## BellBendCOLPEm Resource

**From:** Temple, Jeffrey  
**Sent:** Thursday, October 08, 2009 9:17 AM  
**To:** Jones, Joe A  
**Cc:** BellBendCOL Resource  
**Subject:** FW: BBNPP RAI 47 File Continuation  
**Attachments:** PSP Response Enclosure pgs 41-59.pdf; PSP Response Enclosure pgs 28-40.pdf

**RAI No.:** 47

**ETE-9: Traffic Capacity, Roadway Segment Characteristics**

**Figure K-7: Bell Bend Link  
Node Analysis Network  
Inset 6**

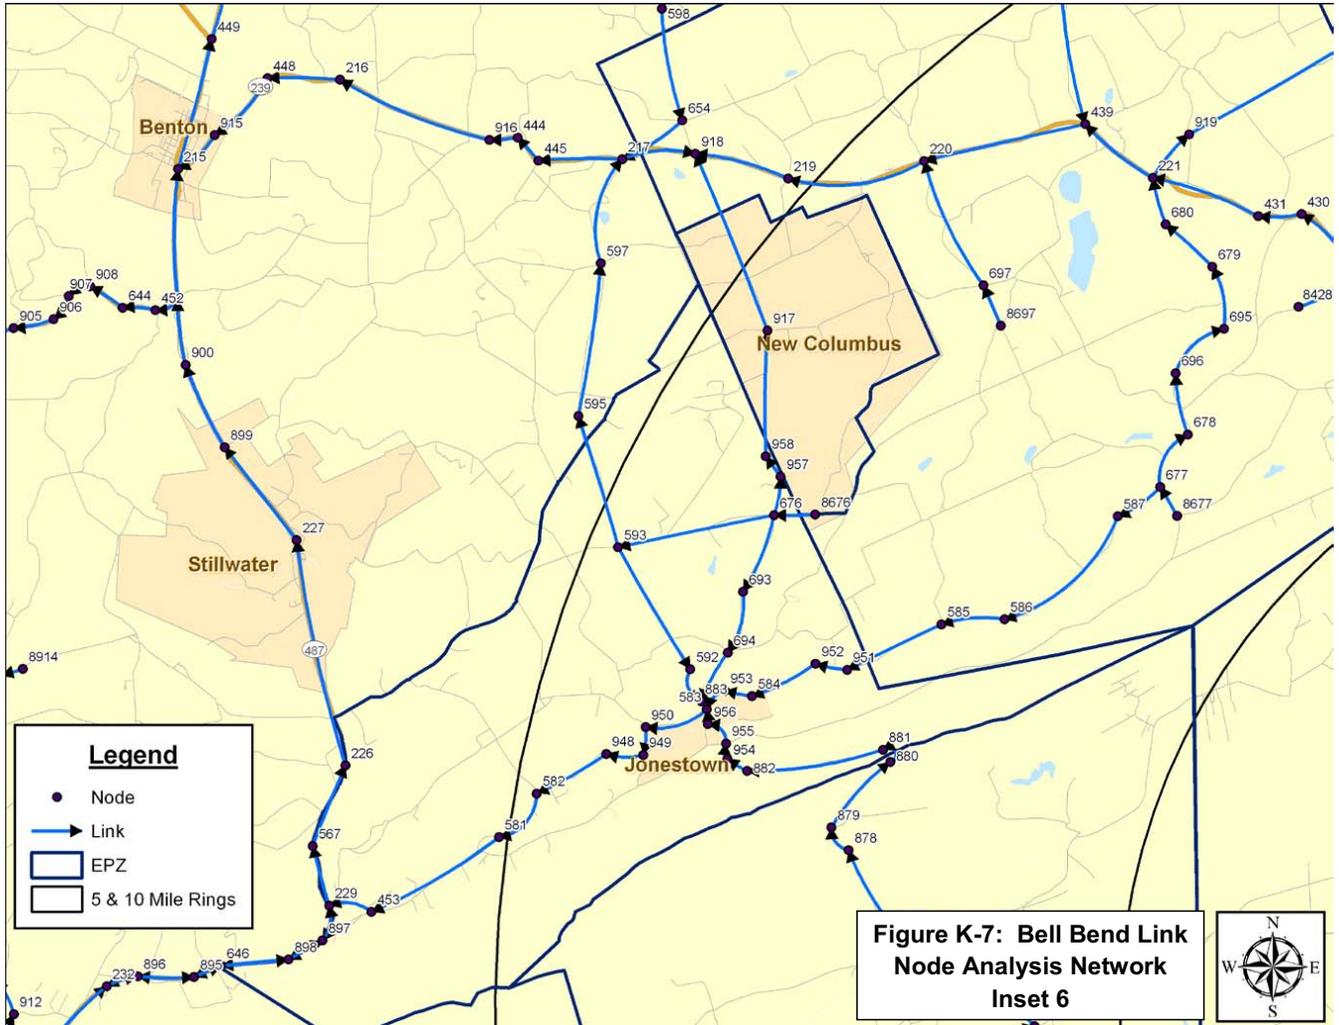
- A. Figure 1-2, "SSES/Bell Bend Link-Node Analysis Network," shows the nodes used in the analysis, but the nodes are not labeled to correspond to Appendix K, "Evacuation Roadway Network Characteristics." Provide a map in a revision to the ETE report that includes legible node numbers that correspond to Appendix K.

Due to the scale of Figure 1-2, the node labels and link directional arrows were removed for clarity. Figure 1-2 will be divided into several figures in Appendix K in a future revision of the ETE report, which will show the directional arrows and annotate the nodes within the link-node analysis network. The reference to Figure 1-2 in Section 1.3 will be revised to reference the newly added figures in Appendix K; these newly added figures are attached to this response.

As discussed in Section 1.3, a computerized link-node analysis network was constructed to model the evacuation roadway network within the study area. Figure K-1 provides an overview of the link-node analysis network. The figure has been divided up into 18 more detailed figures (Figures K-2 through K-19) which show each of the links and nodes in the network.

4. Insert new figures K-1 through K-19 into Appendix K in a future revision of the ETE Report.
5. Modify the last paragraph in the subsection, "Field Surveys of the Highway Network" to read in a future revision of the ETE Report:

Figure 1-2 presents the link-node analysis network that was constructed to model the evacuation roadway network in the EPZ and Shadow Region. The directional arrows on the links and the node numbers have been removed from Figure 1-2 for clarity. The detailed figures K-2 through K-19, provided in Appendix K depict the analysis network with directional arrows shown and node numbers provided. The observations made during the field survey were used to calibrate the analysis network.
